Determination 2017/041

Regarding whether proposed barriers to a timber walkway and proposed wharf along the shoreline at Mangonui Harbour, Northland will satisfy Clause F4 Safety from falling

Figure 1: Site plan of the proposed wharf and existing timber walkway

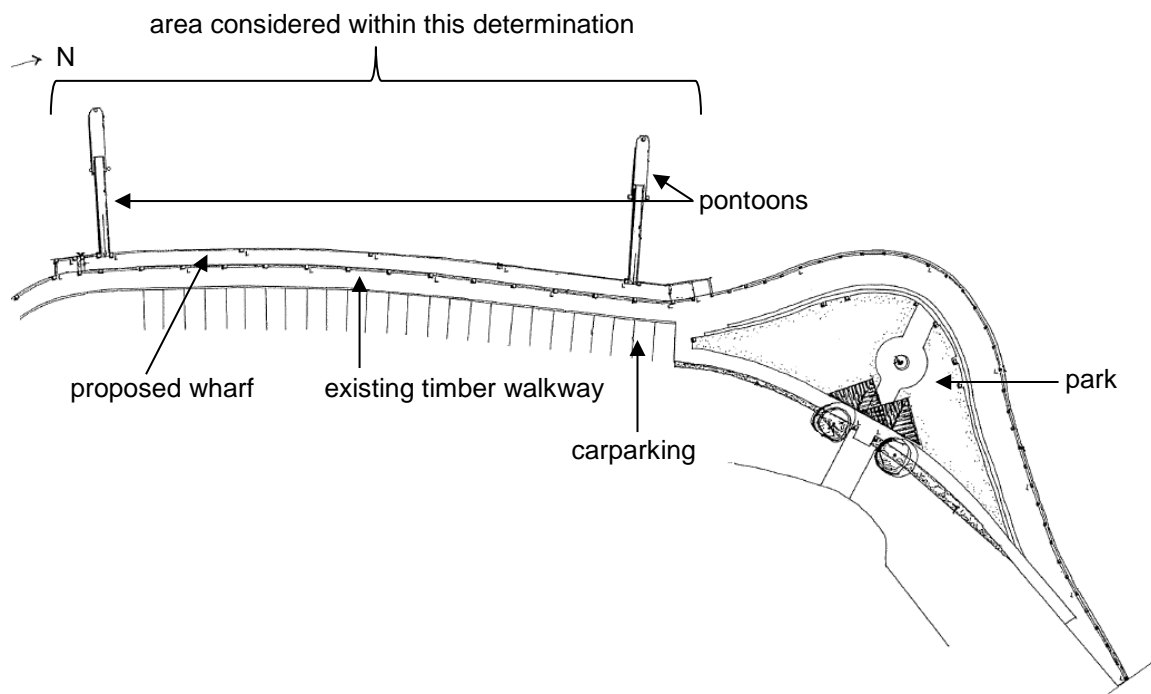
- 2.1 The building work considered in this determination is the construction of a wharf set down 950mm from the adjacent walkway, and a barrier to approximately 80m of the existing walkway where it is adjacent to the wharf (see Figure 1).
- 2.2 An alternative barrier is proposed to the walkway bordering the park, but this is outside the scope of this determination.
- 2.3 The existing walkway is approximately 168m long and is located on the shoreline of the Mangonui Harbour. The walkway is in the order of 4 to 5m wide, and is adjacent to a road, carparking, retail outlets and a hotel. The area considered in this determination is shown in Figure 1.

Figure 2: Diagram of proposed barriers to the wharf and walkway

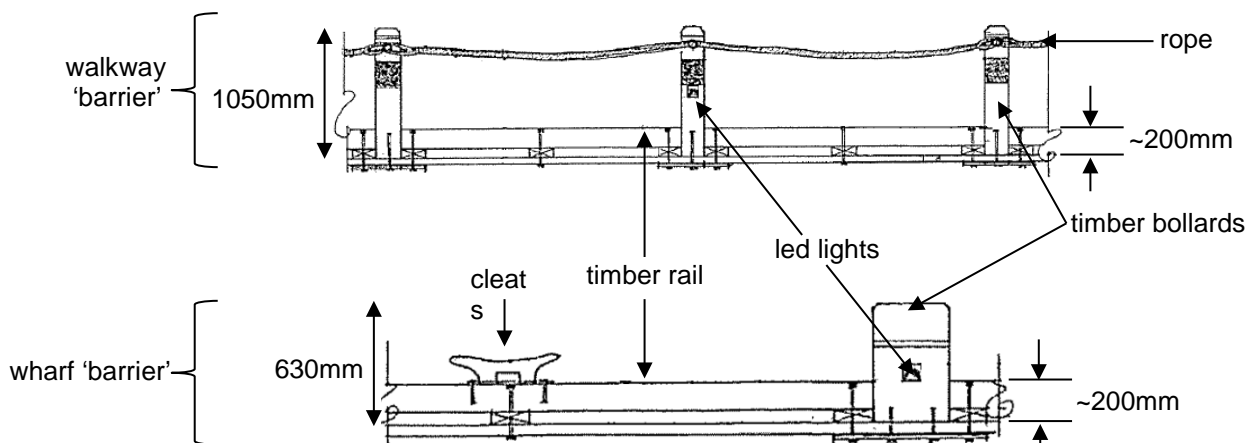
5.5.1 The 1 metre fall height stated in Clause F4.3.1 recognises that falls from this height are likely to result in significant injury; consequently, a fall from a height of less than 1m will satisfy Clause F4.3.1. The presence of the wharf at 950mm below the walkway means that someone is unable to fall vertically 1m or more.

5.5.2 I have discussed in previous determinations⁷ that the fall height cannot be calculated only in terms of the vertical height above the surface immediately below it. Any forward momentum of a person falling or a child running off must be taken into account, ensuring that the landing area is adequate. It is important to consider whether the width of the wharf is sufficient to prevent a person from being at risk of a further fall.

5.5.3 In Determination 2008/81, SNZ HB 8360⁸ was used to calculate whether a landing area had a sufficient width. Although SNZ HB 8360 is not a cited document in the Acceptable Solutions, it takes account of the likelihood that a person falling from the edge will continue to fall from the initial landing area. Using Table 20 in the document and based on the fall height, the landing area in this case would be required to be 1.5m.

5.5.4 At 2.0m wide the wharf has sufficient width to prevent a person’s forward momentum from causing a further fall. Taking that into account with the vertical fall height of less than 1m, I therefore conclude a safety barrier is not required to the seaward edge of the walkway.

- 5.6.1 Determination 1995/004⁹ noted that safety barriers are incompatible with the intended use of working wharves because a barrier would prevent a person moving from their boat to the wharf and vice versa. It is important to establish whether the wharf in this case is a working wharf and the limitation on Clause F4.3.1 would apply.

- 5.6.2 The proposed wharf is separate from the walkway and has a different proposed use. The authority provided a letter that outlined the intended use of the area as a wharf for recreational boats (see paragraph 4.2). I consider it salient that design elements necessary for the wharf to function as a working wharf have been proposed, such as the iron cleats and additional space provided by the pontoons to tie boats up.

- 5.6.3 I accept that the wharf will be used as working wharf, and a barrier would prevent the transition of people from boats to the wharf. Therefore, the limitation on Clause F4.3.1 applies as a barrier would be incompatible with the intended use. I note that while it is possible for people to walk along the wharf, in this particular instance in this location there will be adequate supervision of children under the age of 6 years old.

- 5.7.2 I provide the following comments to the authority to consider in regard to the proposed design. The raised timber rails, substantial timber bollards that are lit, and rope running along the length of the walkway provide visual clues that alert people to the edge and the change in level. Likewise the raised timber rails and timber bollards with lights are visual clues that will alert people to the edge and the change in level for the wharf.

- the section of the walkway considered in this determination with the wharf constructed at 950mm below does not require a barrier to comply with Clause F4 of the Building Code, and
- the limits on application to Clause F4.3.1 apply to the proposed wharf;
